**ADDENDUM NUMBER 3**

**ISSUE DATE: SEPTEMBER 09, 2003**

**PROJECT: ALLEN PARK TENNIS COURTS AND SIDEWALK IMPROVEMENTS -  
JONESBORO, ARKANSAS.**

**PROJECT NUMBER: 020304**

Attachment - D

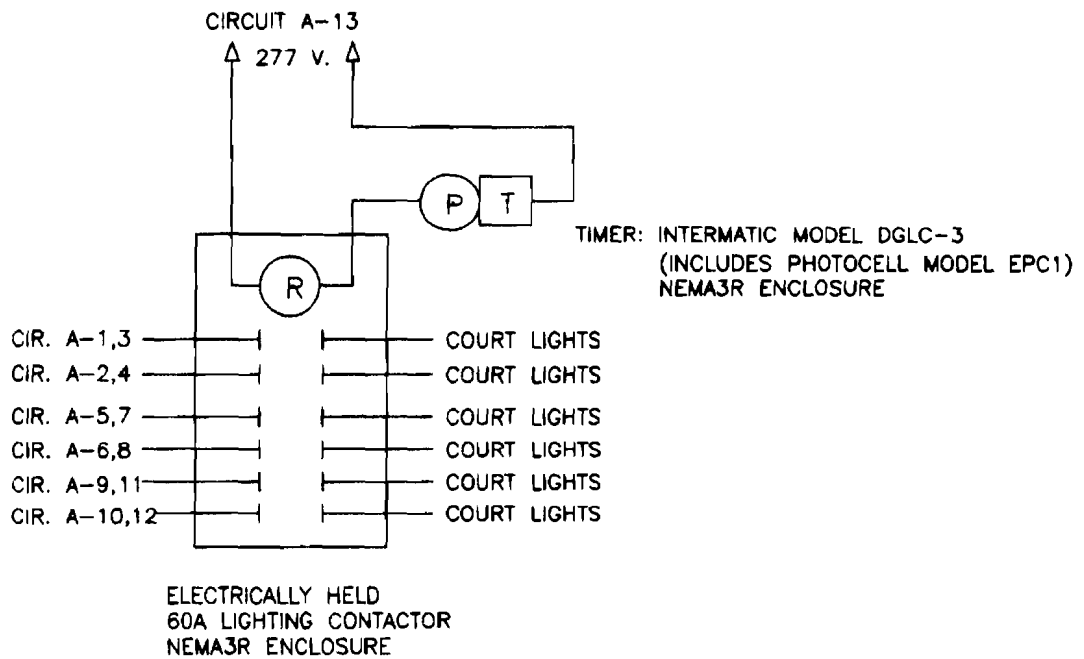
2. Control of lighting for courts shall be by photocell, timer and contactor - See Attachment "D".
